STATE OF MICHIGAN
DEPARTMENT OF NATURAL RESOURCES
LANSING

August 23, 2012

Re: Fisheries comments concerning DEQ file no. 12-81-0027-P

The Michigan Department of Natural Resources (DNR), Fisheries Division is providing comment on the Michigan Department of Environmental Quality (DEQ) permit application titled "MichCon Broadway Street MGP Whitewater and Habitat Improvements" (DEQ file no. 12-81-0077-P). The DNR met on two separate occasions with representatives from DEQ, City of Ann Arbor, TRC and Recreational Engineering and Planning (REP) to discuss the proposed project.

Longitudinal Profile

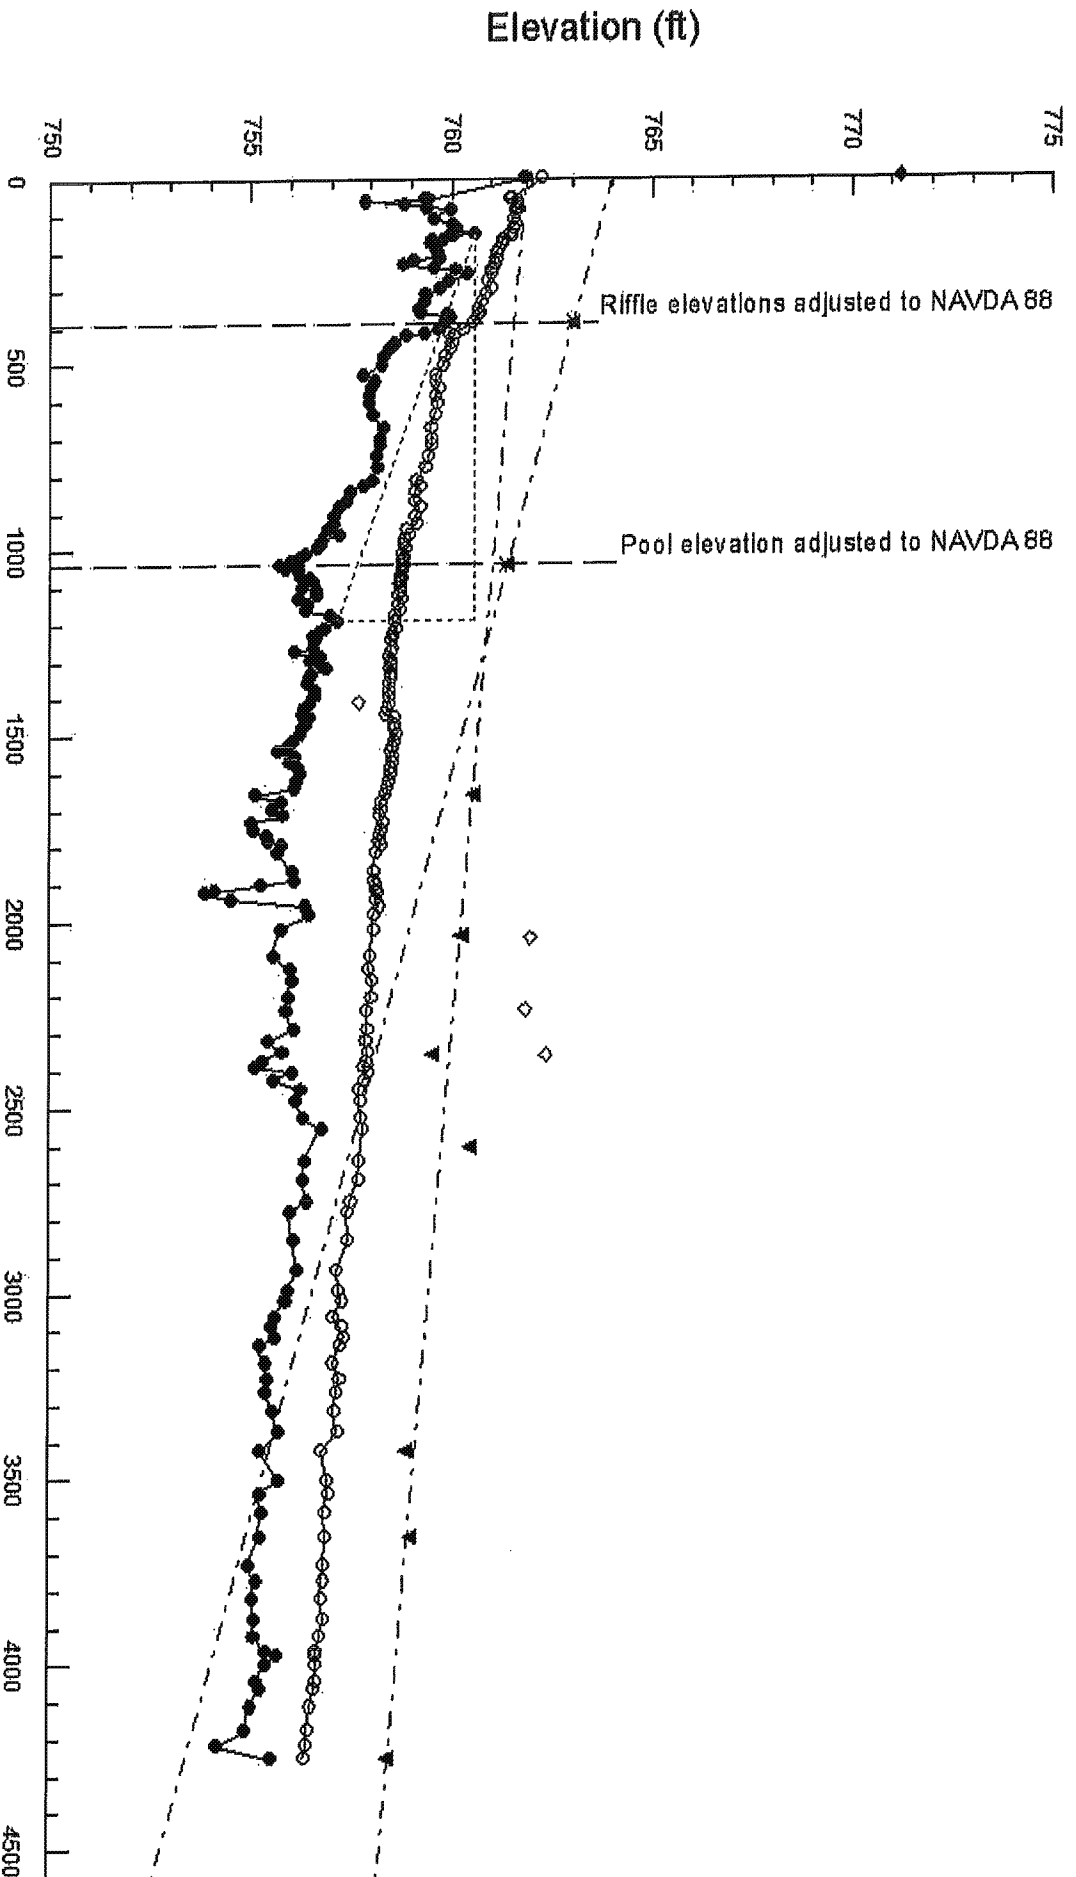
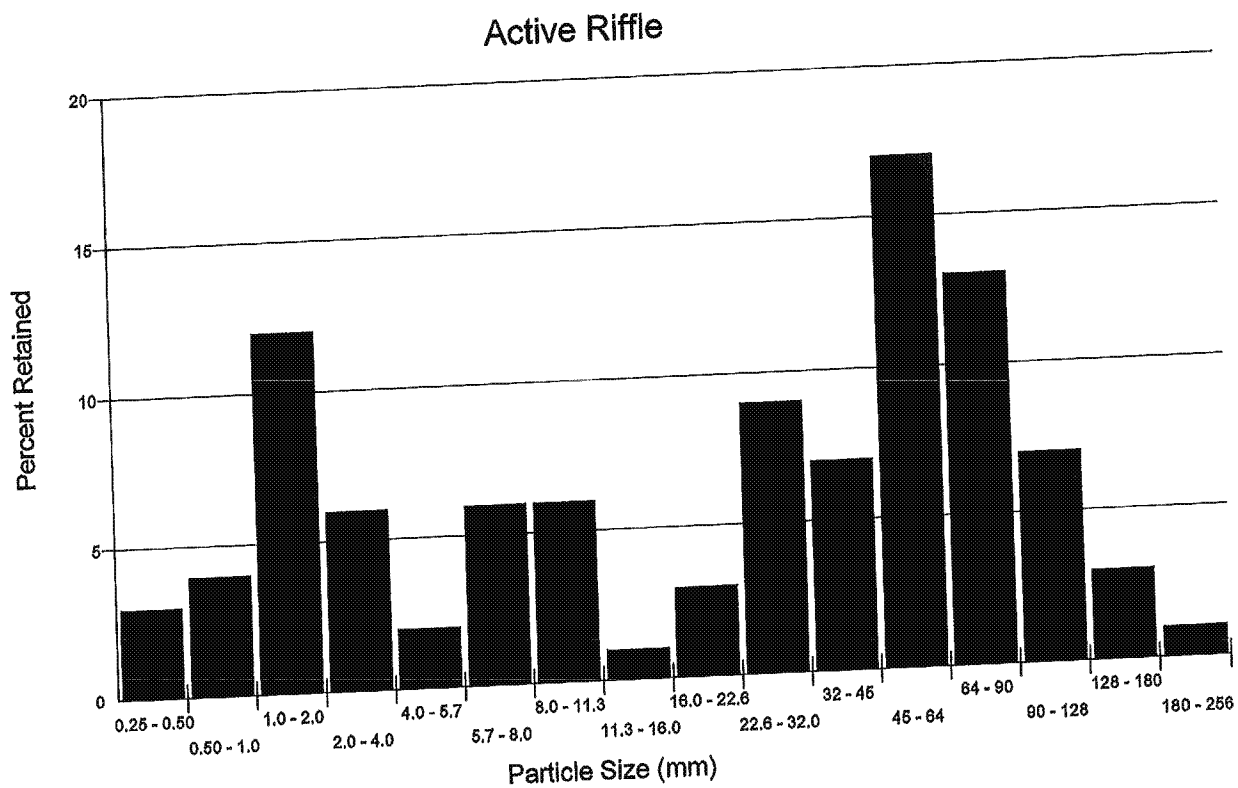
Distance = 1685.98 Depth = -3.42 Slope = -.0033
